RE: Smith Ranch – Highland Uranium Project
Docket No. 40-8964, SUA-1548
A-Wellfield Ground Water Restoration Information

RE: Permit 603-A2
A-Wellfield Ground Water Restoration Report
Request for Concurrence to Commence Stability Monitoring

**RE: TFN 3 4/261, Review of the A-Wellfield Groundwater Restoration Report,
Power Resources Inc., Permit No. 603**

Figure 1., Contoured A-Wellfield Water Level Elevations, 01/27/2000

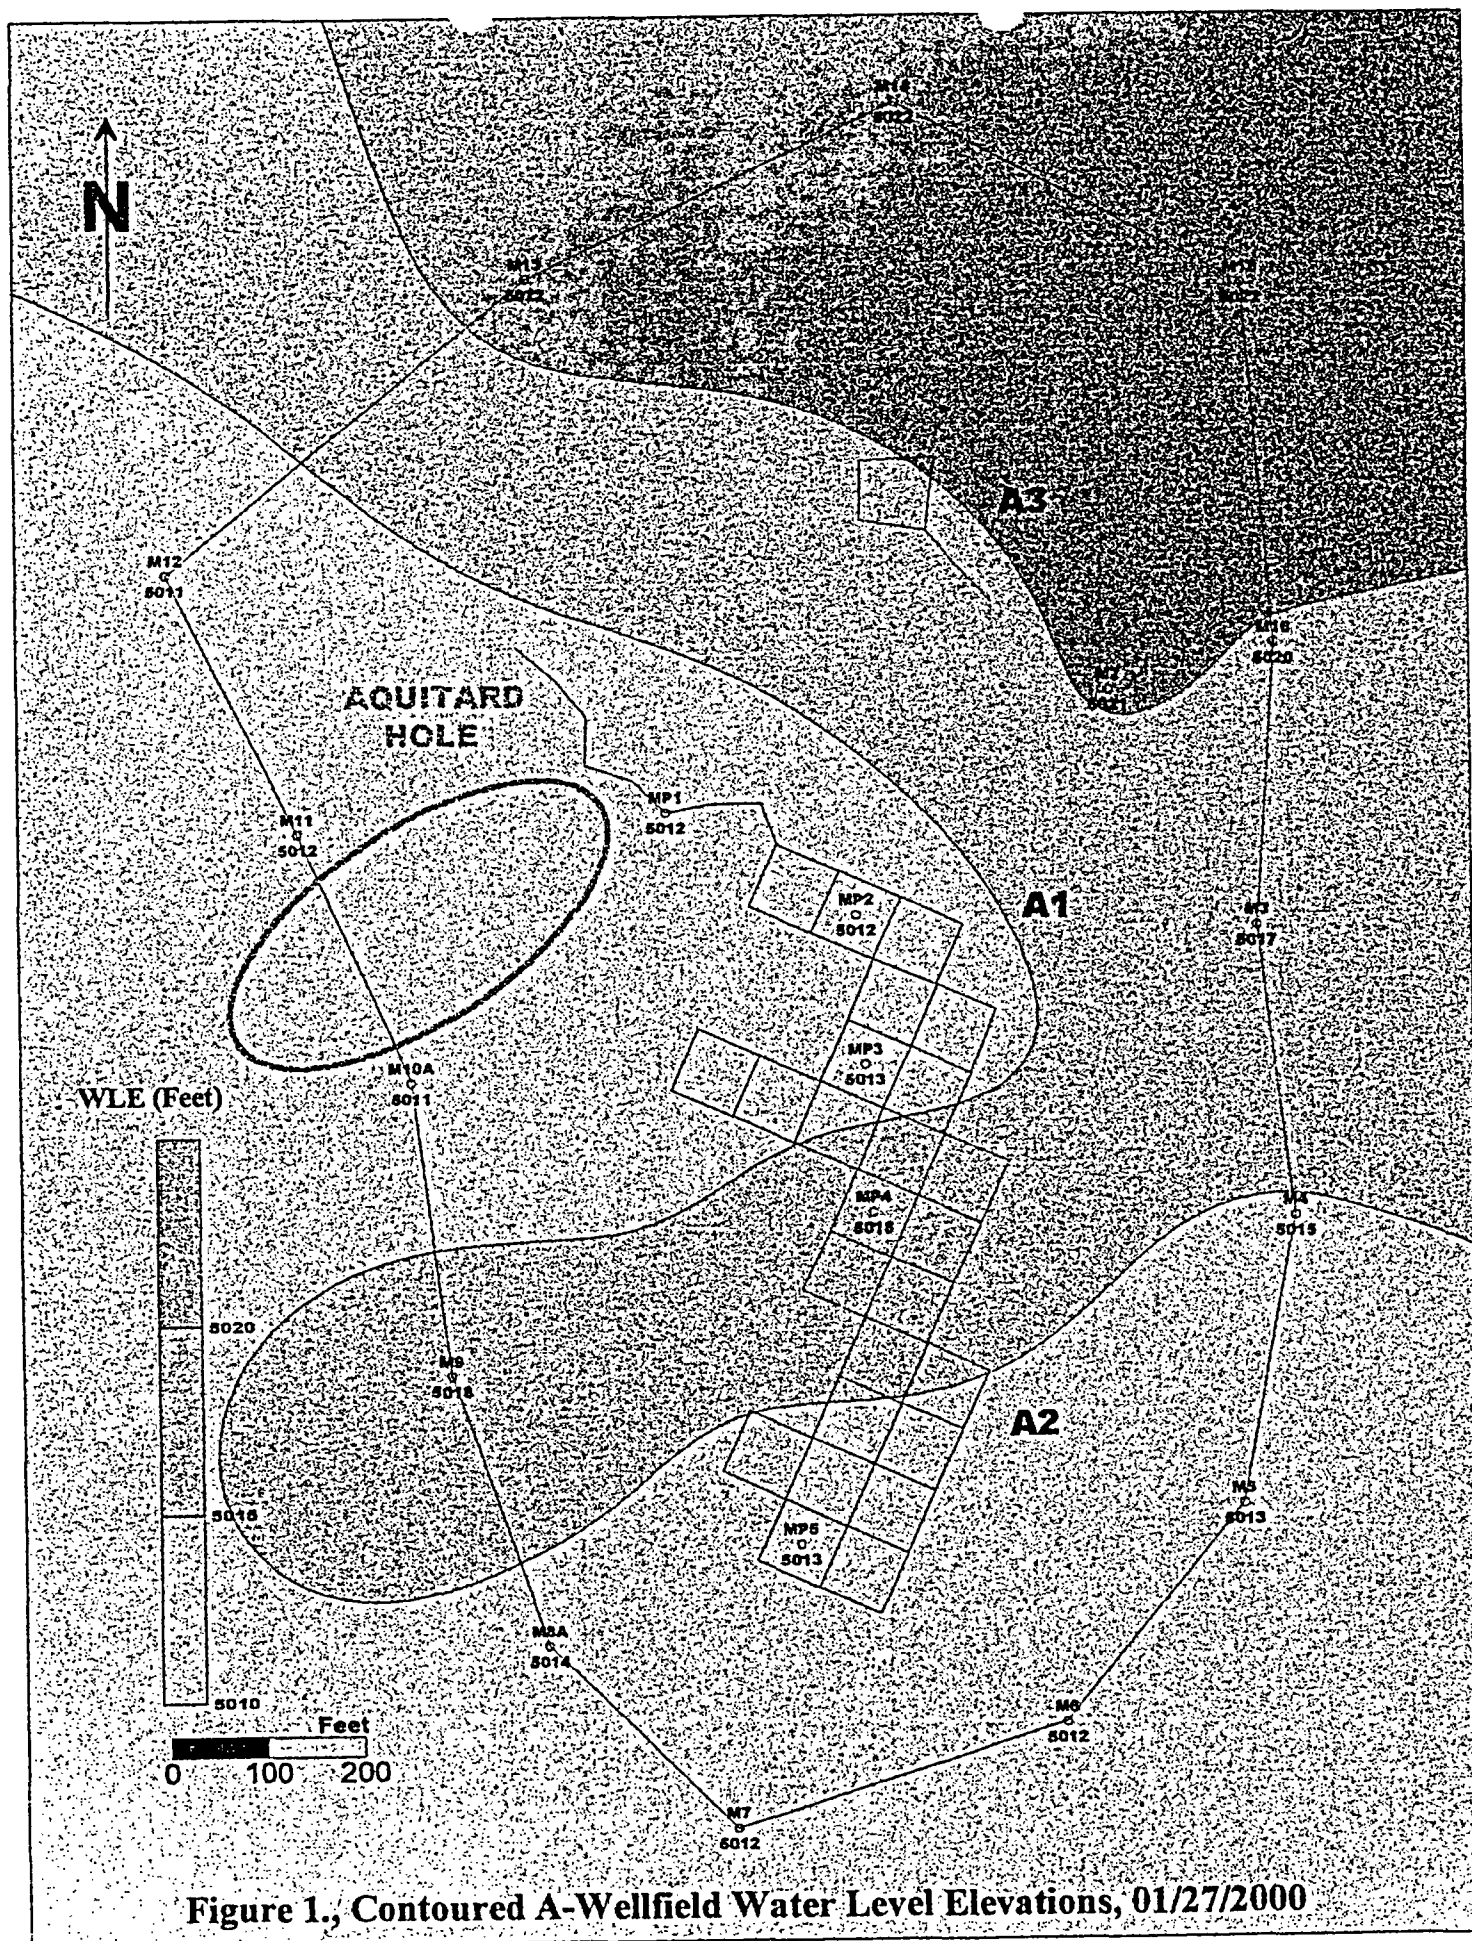
Please provide an end of stability potentiometric surface map and at least six months of water level data, when obtained, to determine if the ground water flow pattern is stable.

A potentiometric surface map, which was developed from water level data collected at the end of stability, is provided as Figure 1 in the A-Wellfield Ground Water Quality Stabilization Report. As discussed in Section 2.2.1, Potentiometric Surface Map, this map shows that the ground water flow pattern is stable. Water level data are included for all of 1999 in Appendix 5.2.
